**ALTO MAIPO****OWNER'S INSTRUCTION**  
Section 2.29  
PHAM-PLN12-INS-0003

Contract:	<input type="checkbox"/> AM-CO610/620B <input checked="" type="checkbox"/> AM-CO630/620A	SI 6332/ N° 0495
Scope Segment Description:	TCS (Tunnel cable shaft)	
Location:	Ch: 0+005,5 VLS to TCS. Time for Compliance: Immediately

Tunnel	VLS to TCS (Tunnel cable shaft)
Instruction N°	495

Position of Grout holes:

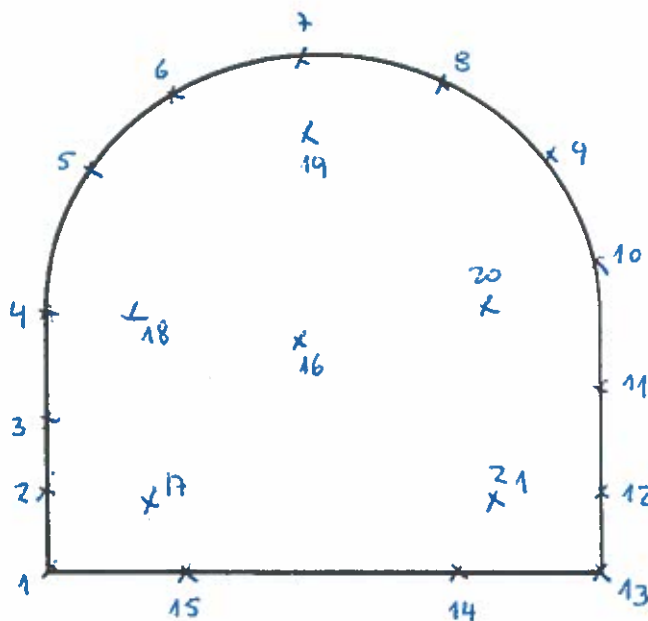
**Instruction:** The contractor is here with instructed to systematically grout the remaining tunnel. The grout curtains shall have an overlap of 6M. However, the OE will issue a separate grout instruction for each curtain. The grouting shall be carried out as described in the following:

- the holes shall be drilled as indicated in the attached sketch. Drill holes 1-15 shall be drilled with an 15° angle to the tunnel axis
- Drill the primary round (holes 1, 9, 3, 11, 5, 13, 7, 15) and grout
- Drill the secondary round (holes 2, 10, 4, 12, 6, 14, 8) and grout
- Drill holes 16, 17, 18, 19, 20, 21 parallel to the tunnel axis and grout in the last holes (16-21) packers shall be installed at 10 M depth

- 1) out of the primary round hole N°3 shall be used and logged as exploratory hole and used to carry out a Lugeon test.

Contractor comments (if any): IN THE HOLES 16-21 PACKER SHALL BE INSTALLED AT 6,0 m DEPTH!
